APPLICATION FOR A RESIDENTIAL SITE IMPROVEMENT PERMIT/ CONSTRUCTION AUTHORIZATION FOR AN ON-SITE WASTEWATER SYSTEM, NEW WELL INSTALLATION, OR REPAIR OF EXISTING WELL

Re: Application for improvement permit for: 3 Bedroom House
Property Location: 214 Halsey Ct, Charlotte, NC 28208 (PID 065-143-36)
Health Department File Number: **10202B (App ID 10158)**

SOIL/SITE EVALUATION for ON-SITE WASTEWATER SYSTEM

Sketch of Soil Evaluation Locations

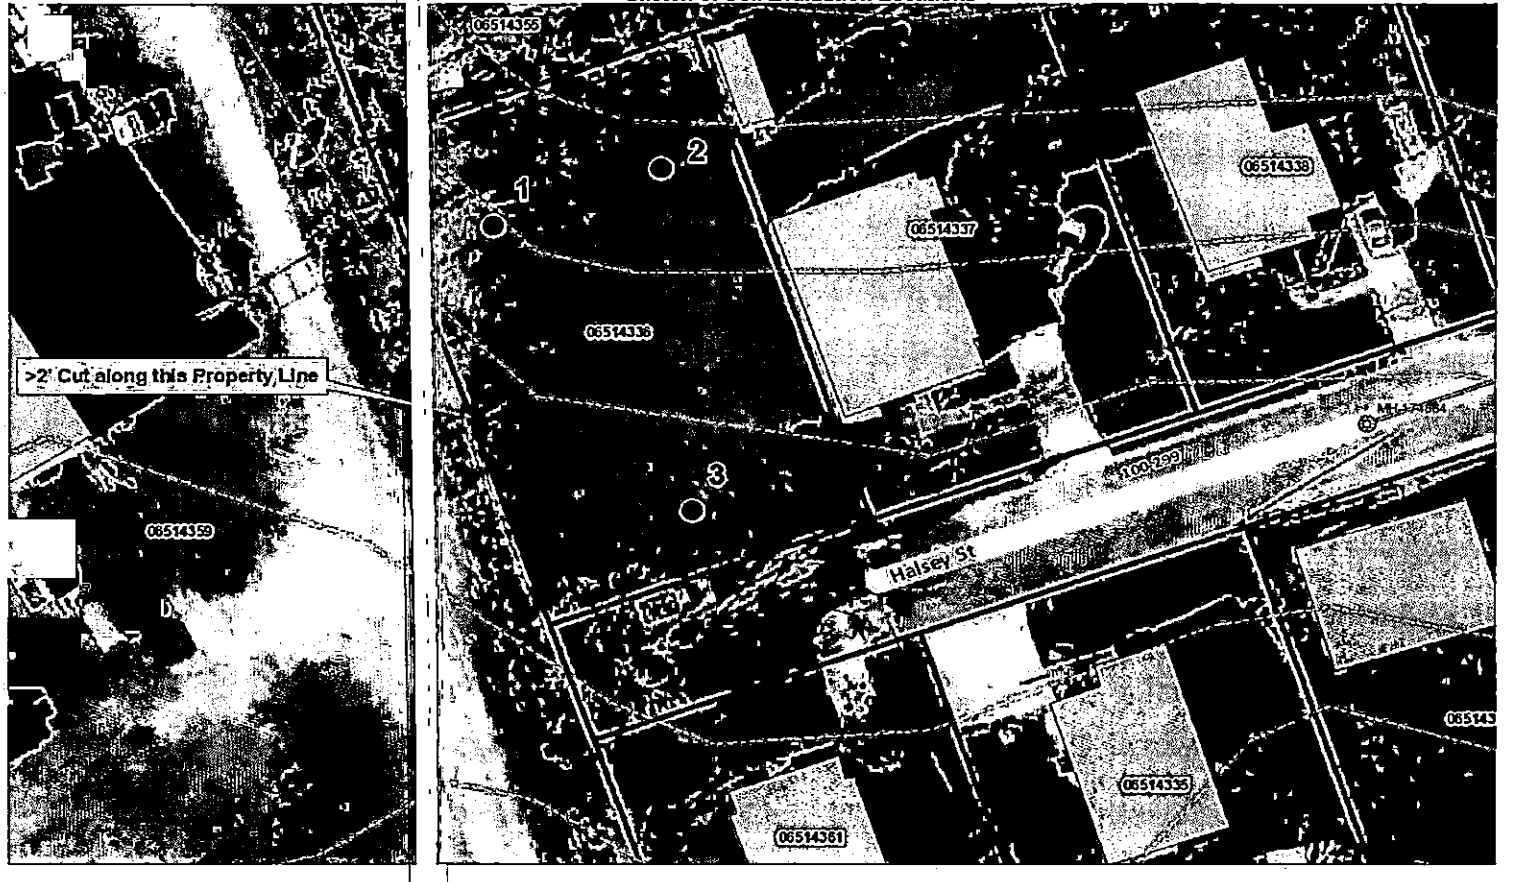
Based on the criteria set out in Title 15A, Subchapter 18A, of the North Carolina Administrative Code, Rules .1940 through .1948, the evaluation indicated that the site is **UNSUITABLE** for a ground absorption sewage system. Therefore, your request for an improvement permit is **DENIED.** A copy of the site evaluation is enclosed. The site is unsuitable based on the following:

- ☐ Unsuitable soil topography and/or landscape position (Rule .1940)
- ☒ Unsuitable soil characteristics (structure or clay mineralogy) (Rule .1941)
- ☒ Unsuitable soil wetness condition (Rule .1942)
- ☒ Unsuitable soil depth (Rule .1943)
- ☐ Presence of restrictive horizon (Rule .1944)
- ☒ Insufficient space for septic system and repair area (Rule .1945)
- ☐ Unsuitable for meeting required setbacks (Rule .1950)
- ☐ Other (Rule .1946)

PROFILE #	.1940 Landscape Position/ Slope%	Horizon Depth (IN.)	SOIL MORPHOLOGY .1941 .1941 Structure/ Texture	.1941 Consistence Mineralogy	b PROFILE FACTORS .1942 Soil Wetness/ Color	.1943 Soil Depth (IN.)	.1956 Sapro Class	.1944 Restr Horiz	General Comments	Profile Class & LTAR	Maximum Trench Bottom Depth for 3' Wide Conventional Trench
Boring #1	LS 5%	0 - 25	Fill		>25"	0	NA	NA		US	NA
Boring #2	LS 5%	0 - 6	gr CL	SS SP FR SEXP	5YR 5/1 at 16"	24	NA	NA		US	NA
		6 - 24	sbk C	S VP VFI EXP							
Boring #3	HS 2%	0 - 8	sbk SCL	SS SP FR SEXP	5YR 6/1 at 12"	24	NA	NA		US	NA
		8 - 24	mass C	S VP VFI EXP

Description	Initial System	Repair System
Available Space (.1945)	US	US
System Type(s)	NA	NA
Site LTAR (gpd/sq ft)	0	0

Other Factors (.1946):
Soil Evaluation By: Jacob Presley, LSS, REHS
Others Present:
Site Classification (.1948): Unsuitable
Site Evaluation By: Jacob Presley, LSS, REHS
Others Present:

However, the site classified as **UNSUITABLE** may be classified as **PROVISIONALLY SUITABLE** if written documentation is provided that meets the requirements of Rule .1948(d). A copy of this rule is enclosed. You may hire a consultant to assist you if you wish to try to develop a plan under which your site could be reclassified as **PROVISIONALLY SUITABLE.**
